Stability Pathfinder Phase 2 FAQ

Updated 29/10/21

This document contains the questions submitted at the RFI stage from July 2020. We have updated some of the responses to reflect the latest information. As the EOI progresses we will update this document with EOI webinar questions and common questions we are receiving.

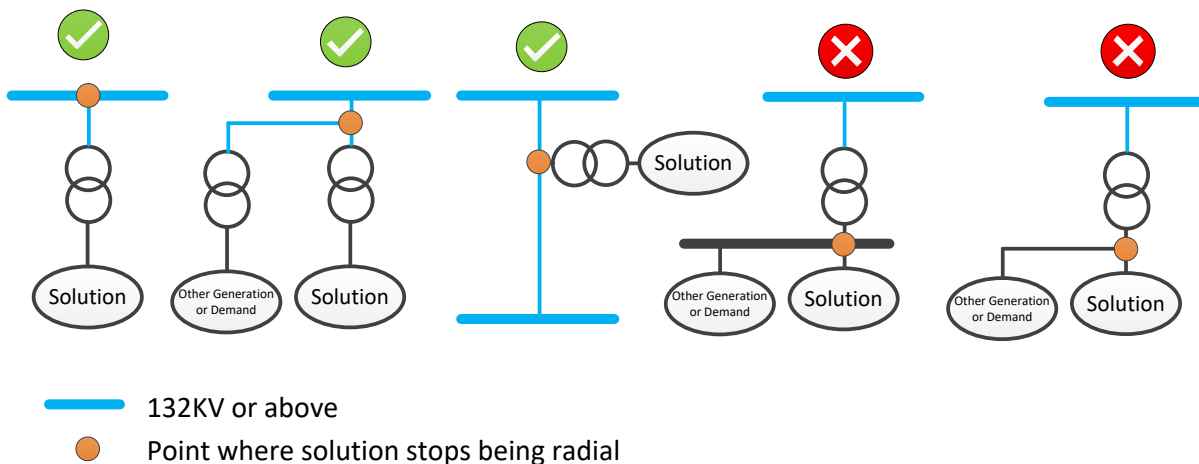
30. Why were these 8 locations picked? (added 06/11/20)

This is based on our system needs and studies. See Q13 for more information.
